UNITED STATES PATENT AND TRADEMARK OFFICE

Office Action Summary

10/664,371

DETAILED ACTION

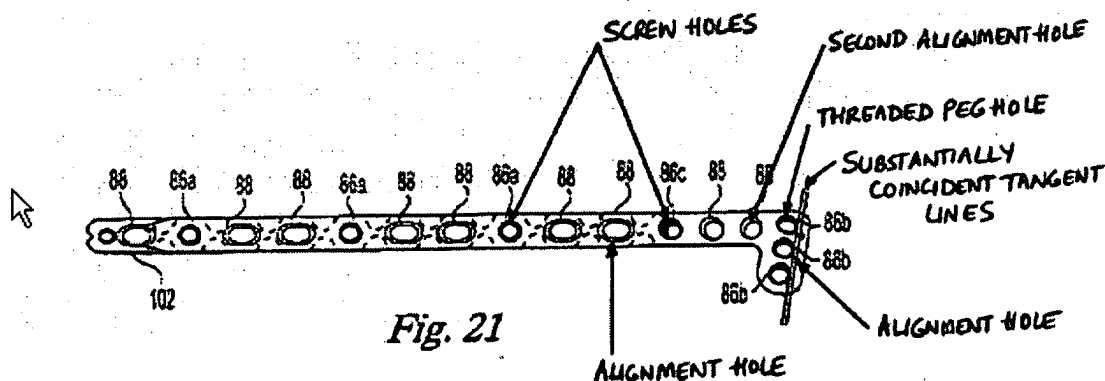
Claims 37-38, 45-48, 51 and 53-55 are rejected under 35 U.S.C. 102(e) as being anticipated by Weaver et al. (US 6,623,486).

Weaver et al. disclose a bone fixation plate 80 including: a head angled relative to a the shaft; the head portion defining a first set of threaded holes 86b; alignment holes much smaller in diameter than the threaded holes for provisional fixation of the bone plate; a second alignment hole 88; and a plurality of screw holes 86a in the shaft of the bone plate (Figs. 20-26, col. 6, lines 58-67 and col. 7, lines 1-17). See marked up Fig. 21 from Weaver et al. below.

Regarding claim 48, Weaver et al. clearly disclose a shaft having a plurality of holes or "screw holes" with alignment holes (either 88 or 86a) that are configured to receive a K-wire that could be oblique relative to the bone contacting surface of the plate depending on the angle of insertion, i.e., predetermined fixed axial orientation.

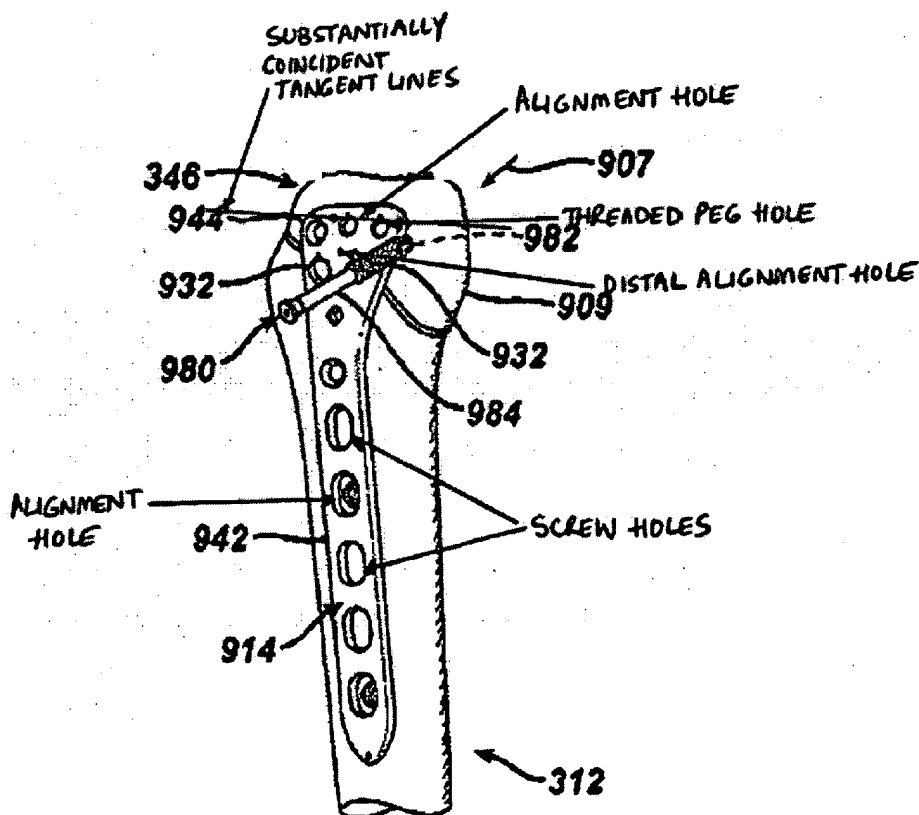
Claims 37-38, 40-43, 45-46, 48-51, 53-55, 58-59 and 65-69 are rejected under 35 U.S.C. 102(e) as being anticipated by Wack et al. (US 2004/0030339 A1).

Wack et al. disclose a plate 914 defining a first set of peg holes structurally adapted to engage a threaded head of a fixation peg and at least one non-threaded alignment hole 871 having a second relatively small diameter wherein the first alignment hole defines a tangent line substantially coincident with a line tangent to the first set of threaded (Figs. 20-22 and paras [0118]-[0162]). See a portion of Fig. 20 marked up to show features of Applicant's invention below.

Contrary to Applicant's arguments with respect to claim 37, Wack et al. clearly disclose alignment holes that are proximally placed, i.e., "not displaced distally relative to a distal tangent line between two respective peg holes."

Regarding K-wire holes 871, the Examiner notes that the hole(s) is(are) capable of receiving K-wire(s) in a predetermined fixed axial orientation, i.e., direction of

insertion chosen by the surgeon, such that the K-wire(s) are oblique to a bone-contacting surface of the plate due to the angled head of the bone plate.

The Examiner also notes that the limitation, "sized to closely receive the K-wire" only requires that the hole be capable of receiving an appropriately sized K-wire, a limitation that is met by Wack et al.
